NO. 36-38 VICTORIA STREET BURWOOD – DEMOLITION OF EXISTING BUILDING & CONSTRUCTION OF A MIXED COMMERCIAL AND RESIDENTIAL DEVELOPMENT OVER BASEMENT CAR PARKING – JRPP NO 2012SYE022

TRIM No: 12/23255

Figure 4.1.4 Location of pedestrian links

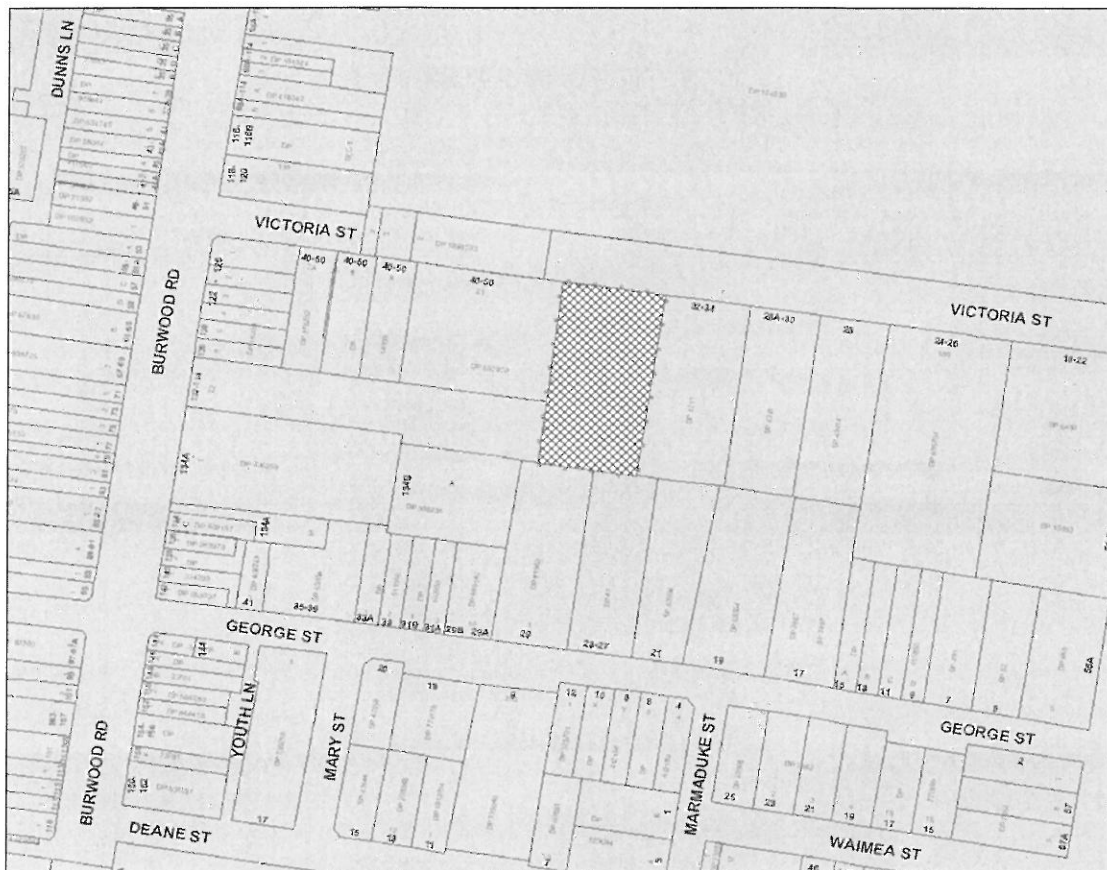
"The diagram showing the location of pedestrian links is indicative only, as at the time of the DCP preparation it was not possible to foresee which sites would be redeveloped and conditions and constraints of sites were unknown. The DCP map (Figure 4.1.4) clearly shows a pedestrian link traversing both the subject site and the adjoining Westfield site, therefore both sites are considered to be affected by the DCP requirement. Other properties affected include No. 132-134 Burwood Road and No. 29 George Street.

Development at No. 36-38 Victoria Street should encompass a pedestrian link, and not be an arcade style. The link should be provided along the western boundary of the site and be a minimum 4.5 metres wide. Due to the level difference between the two sites, the pedestrian link does not have to be strictly straight. However, there should be clear sightlines. A link on this site is also more at the mid point of Victoria Street than the Westfield site.

It is recommended that the applicant be requested to amend the design to provide a public pedestrian link on the western boundary of the site as described above."

Given the above, the proposal is not acceptable as it does not make provision for a public pedestrian link through the western boundary of the site, to allow public access between the streets, when future adjacent sites are developed. Further there is a difference of approximately 4m in ground level between Victoria Street and the rear of No 29 George Street to the south and rear of the subject site. To
